Access Compliance Report

Public Rights-of-Way

(Curb Ramps)

Intersection ID: 2923	Main Street: DOWNFIELD_WOOD_DR	Cross Street: REDSTART_CT	Location: SW
ADA ID: F7F62A0044BD	Ramp Type: PerpDiag	Initial Pass/Fail: Fail	Overall Compliance: No
Severity Score: 22.5			
Codes/Mitigation Info/Possible Solution		Field Measurements/Component Compliance

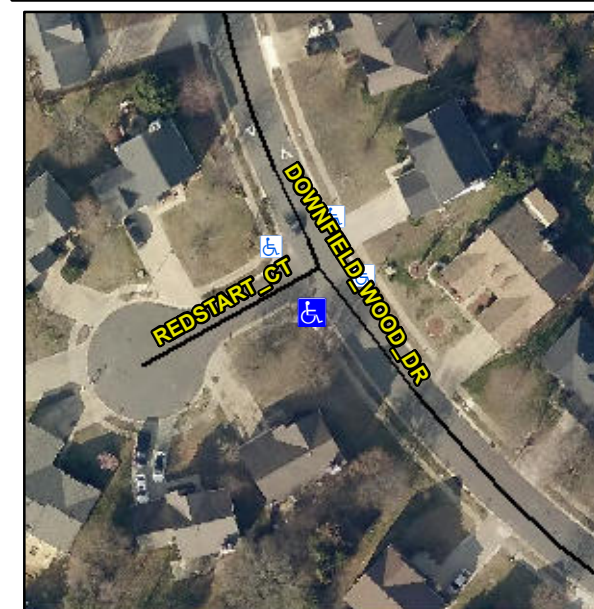
Not Found, R304.5.1, R304.2.2, R304.5.3

Compliance	Description	Data	Compliance	Description	Data
N/A	Ramp Length (in)	48.0	No	Ramp Slope (%)	8.4
No	Ramp Width (in)	43.0	No	Ramp XSlope (%)	2.6
N/A	Flare Type LT	N/A	N/A	Flare Type RT	N/A
N/A	Flare Slope LT (%)	N/A	N/A	Flare Slope RT (%)	N/A
N/A	Flare Traversable LT?	N/A	N/A	Flare Traversable RT?	N/A
N/A	Landing Length (in)	N/A	N/A	DWS Provided?	N/A
N/A	Landing Width (in)	N/A	N/A	DWS Contrast?	N/A
N/A	Landing Slope (%)	N/A	N/A	DWS Length (in)	N/A
N/A	Landing X Slope (%)	N/A	N/A	DWS Full Width?	N/A
N/A	Landing Curb? (Y/N)	N/A	N/A	DWS Offset (in)	N/A
N/A	Shared Landing?	N/A			
N/A	Gutter Ponding?	N/A	N/A	Gutter Slope (%)	N/A
N/A	Gutter Lip Ht (in)	N/A	N/A	Gutter X Slope (%)	N/A
N/A	Painted X Walk1?	No	N/A	Painted X Walk2?	No
	X Walk 1 Direction	To E		X Walk 2 Direction	To N
N/A	X Walk 1 Width (in)	N/A	N/A	X Walk 2 Width (in)	N/A
	X Walk 1 Slope (%)	2.9		X Walk 2 Slope (%)	6.3
	X Walk 1 X Slope (%)	3.8		X Walk 2 X Slope (%)	1.8

Remove & Replace Curb Ramp With Two New Directional Ramps or Equivalent.
